HIGH RISE TASK FORCE

PHASE I & II FINAL REPORT AND PROPOSED CODE CHANGES

**CAL FIRE – Office of the State Fire Marshal
November 2012**

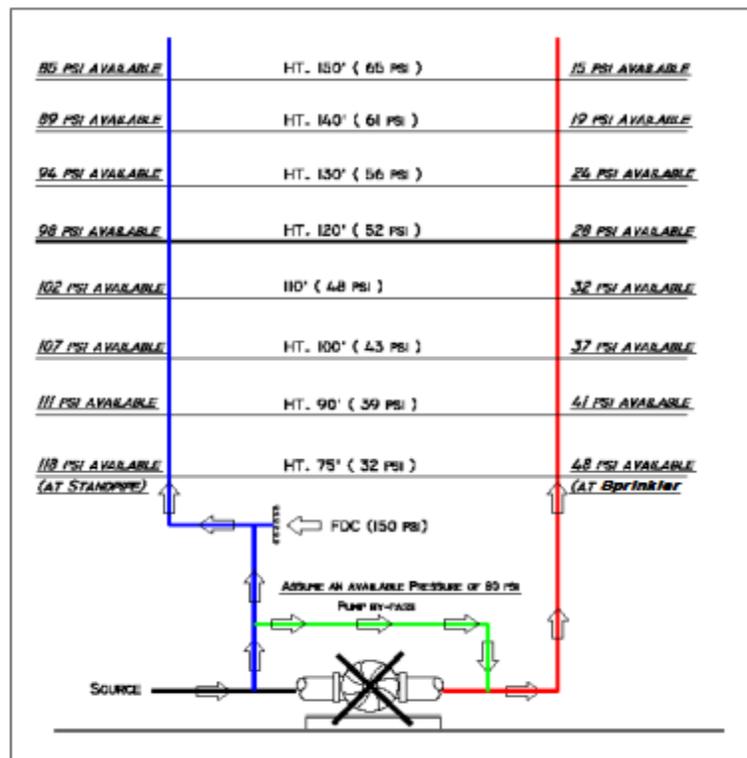
Hydraulic Calculations:

- The schematic diagram below depicts the two water based fire protection system scenarios described above and shows the available pressure at each level for each scenario. The standpipe pressures assume the fire department will pump into the standpipe system at the standard operating pressure of 150 psi.
- The break point is about 120 feet in height where the building height elevation exceeds the fire pump bypass capacity to meet automatic sprinkler system demand and the Fire Department pumper's capacity to meet the standpipe hose demands.
